Project	IEEE 802.16 Broadband Wireless Access Working Group < http://ieee802.org/16 >		
Title	Changing the status of Subchannelization in OFDM mode		
Date Submitted	2003-11-13		
Source(s)	Tal Kaitz, Naftali Chayat, Vladimir Yanover Alvarion John Dring, Intel	Voice: Fax: mailto: Naftali.Chayat@alvarion.com	+972-54-225549 +972-3-6456290
Re:	IEEE 802.16-REVd/D1 Ballot		
Abstract			
Purpose	Material for resolution of comment XXX in LB13		
Notice	This document has been prepared to assist IEEE 802.16. It is offered as a basis for discussion and is not binding on the contributing individual(s) or organization(s). The material in this document is subject to change in form and content after further study. The contributor(s) reserve(s) the right to add, amend or withdraw material contained herein.		
Release	The contributor grants a free, irrevocable license to the IEEE to incorporate material contained in this contribution, and any modifications thereof, in the creation of an IEEE Standards publication; to copyright in the IEEE's name any IEEE Standards publication even though it may include portions of this contribution; and at the IEEE's sole discretion to permit others to reproduce in who

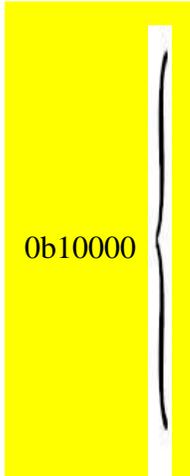
The way we propose to introduce this functionality is to introduce a “Subchannel Index” code for the case that all 16 subchannels are being aggregated into a full bandwidth transmission. This is illustrated below.
